# LIBERTY TREE ACADEMY **CONSTRUCTION DOCUMENTS** TOWN OF PEYTON, EL PASO COUNTY PRELIMINARY DESIGN TO DENVER MAY 2018

# PPR-18-023

# SEAL LIBERTY TREE ACADEMY PRELIMINARY THIS DRAWING HAS NOT BEEN APPROVED BY GOVERNING AGENCIES AND IS SUBJECT TO CHANGE TOWN OF PEYTON, EL PASO COUNTY CONSTRUCTION DOCUMENTS FOR AND ON BEHALF OF MATRIX DESIGN GROUP, INC. PROJECT NO. 18.995.001 POND OUTLET STRUCTURE DETAILS

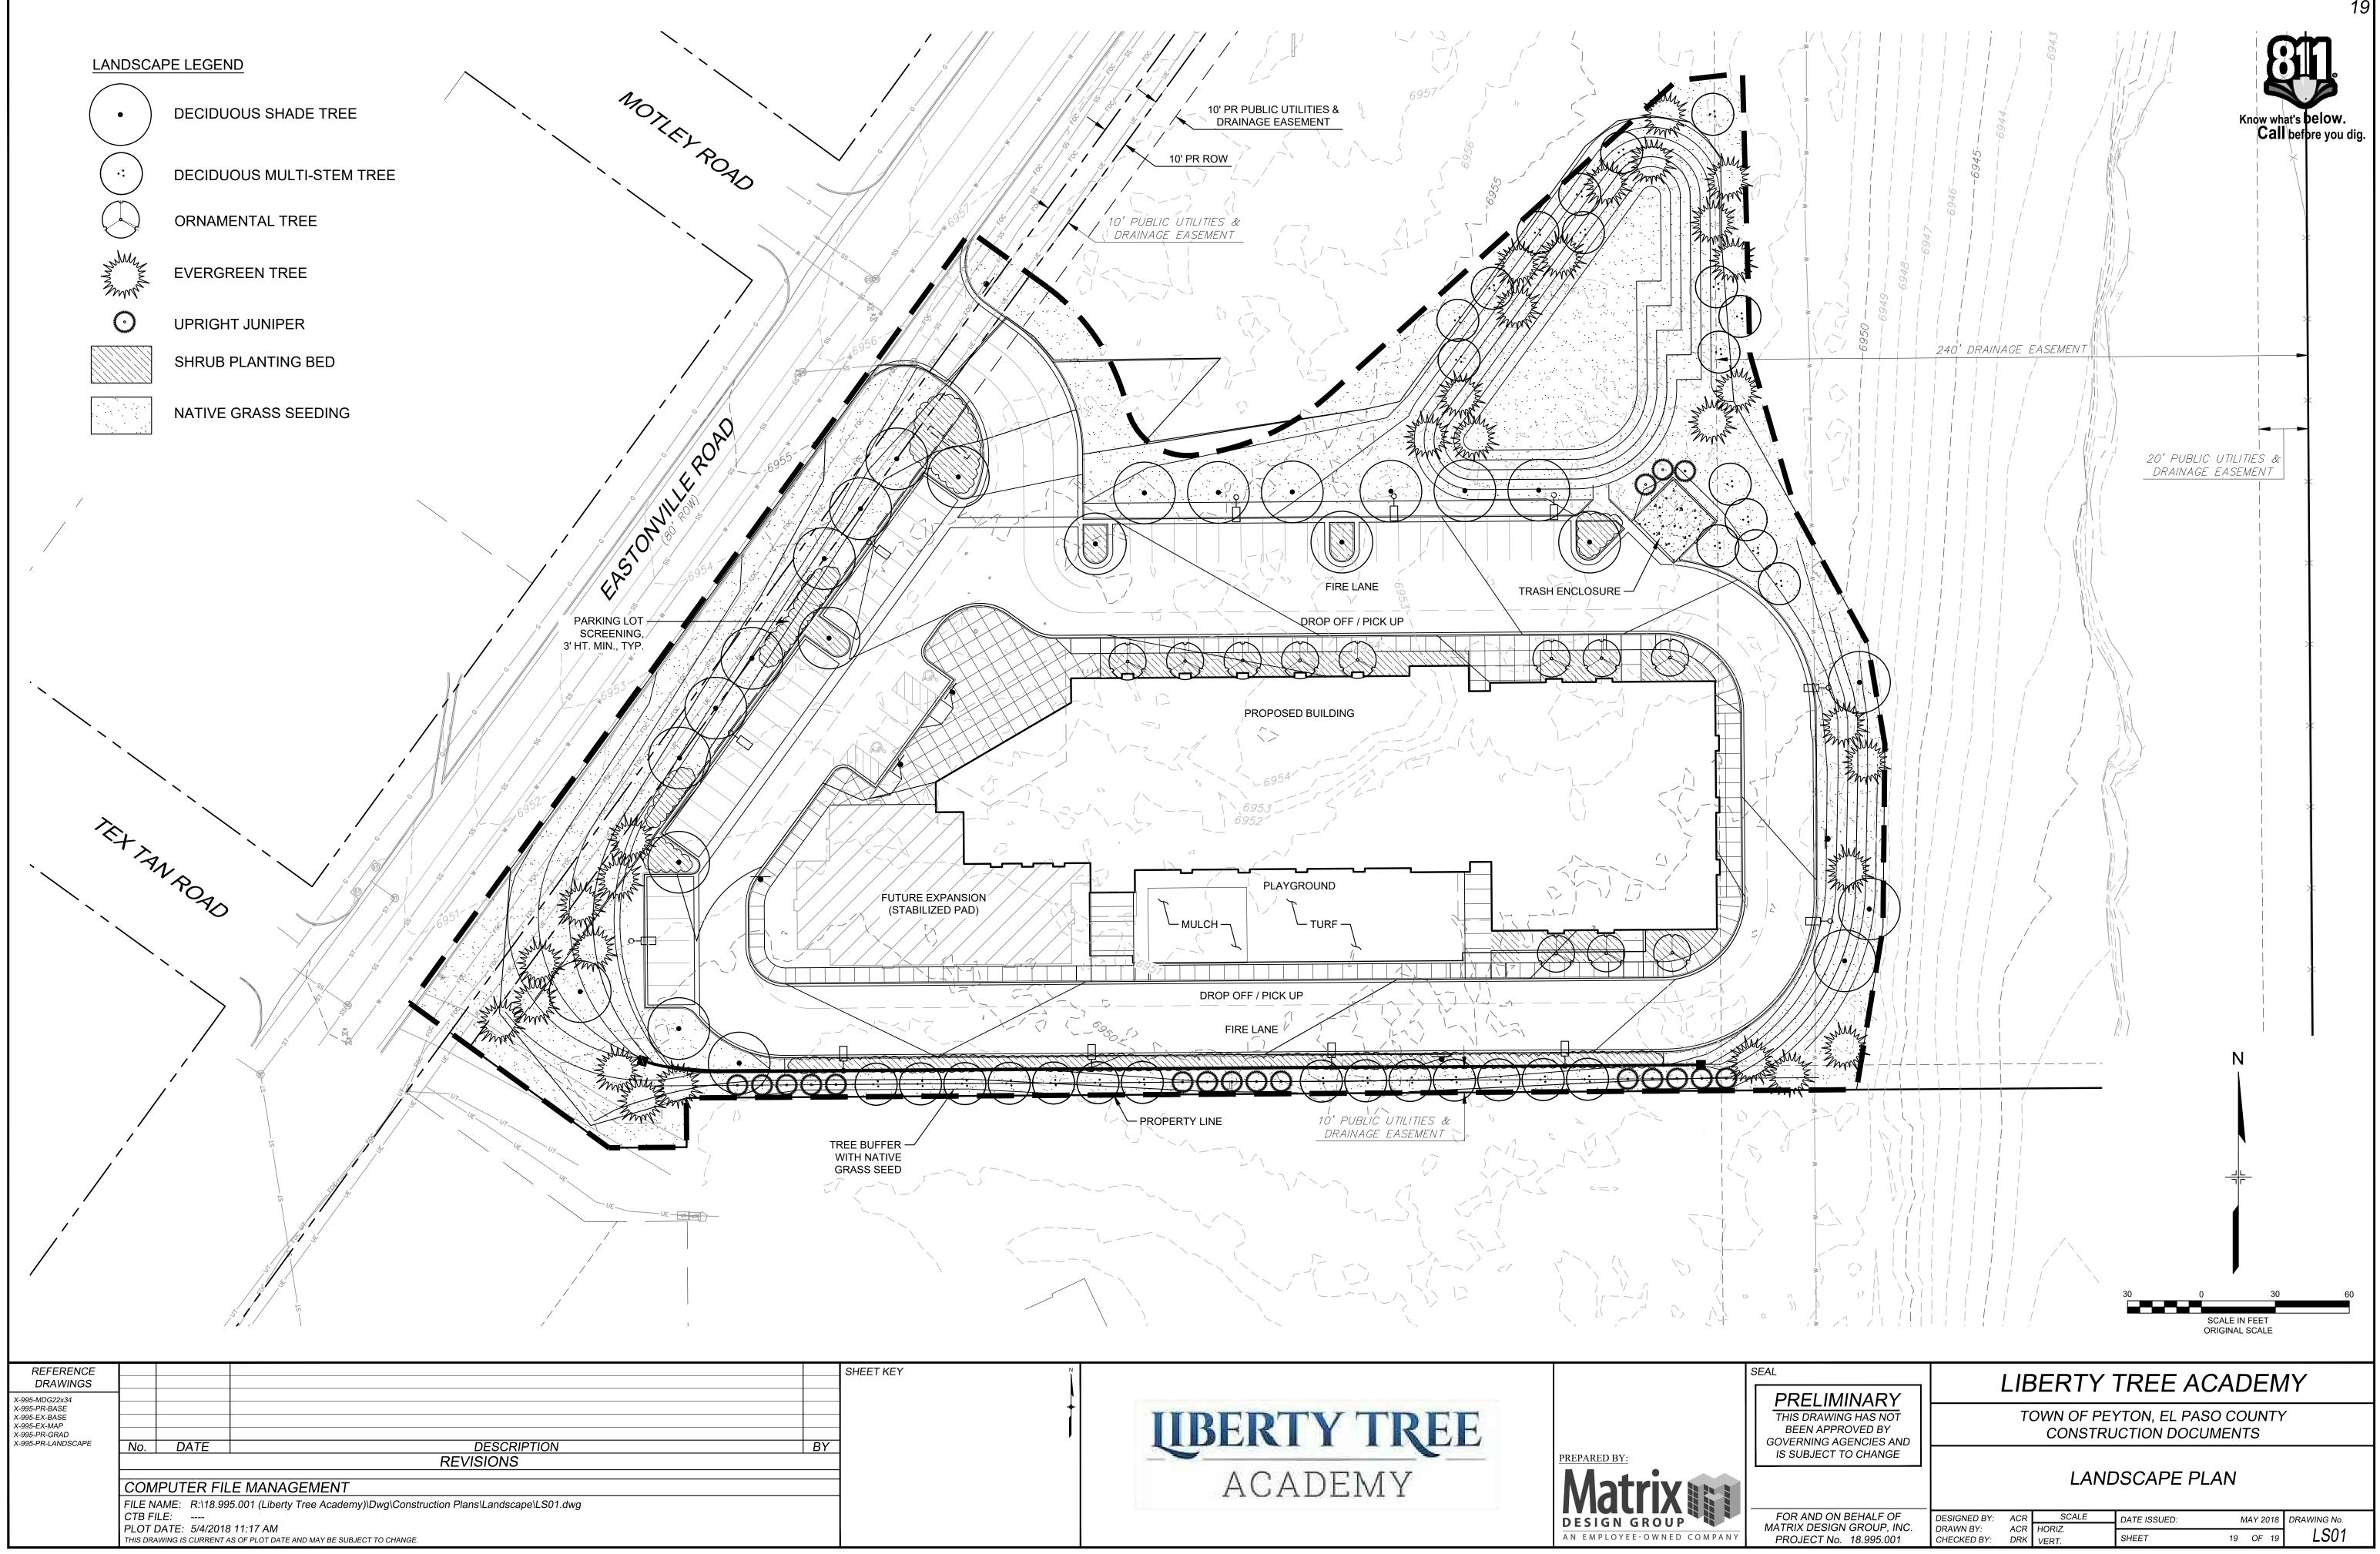
dsdrice (13)		
	Subject: Cloud+ Page Label: [1] TS01 TS01 Author: dsdrice Date: 6/14/2018 10:04:07 AM Color:	Delete/revise with final.
•	Subject: Highlight Page Label: [18] SDT01 SDT01 Author: dsdrice Date: 6/14/2018 10:07:20 AM Color:	
	Subject: Cloud+ Page Label: [13] ECDT01 ECDT01 Author: dsdrice Date: 6/14/2018 10:20:19 AM Color:	75'
75' ( and the second s	Subject: Cloud+ Page Label: [13] ECDT01 ECDT01 Author: dsdrice Date: 6/14/2018 10:21:03 AM Color:	75'
	Subject: Cloud+ Page Label: [12] EC02 EC02 Author: dsdrice Date: 6/14/2018 10:21:36 AM Color:	adjust LOC
	Subject: Cloud+ Page Label: [12] EC02 EC02 Author: dsdrice Date: 6/14/2018 10:22:28 AM Color:	Include in LOC
Brennod Brennod ppeline atio.	Subject: Callout Page Label: [8] SS01 SS01 Author: dsdrice Date: 6/14/2018 12:03:03 PM Color:	Show Diamond Shamrock pipeline also.
Show Diamond Shamrock pipeline also.	Subject: Callout Page Label: [7] UT01 UT01 Author: dsdrice Date: 6/14/2018 12:04:08 PM Color:	Show Diamond Shamrock pipeline also.
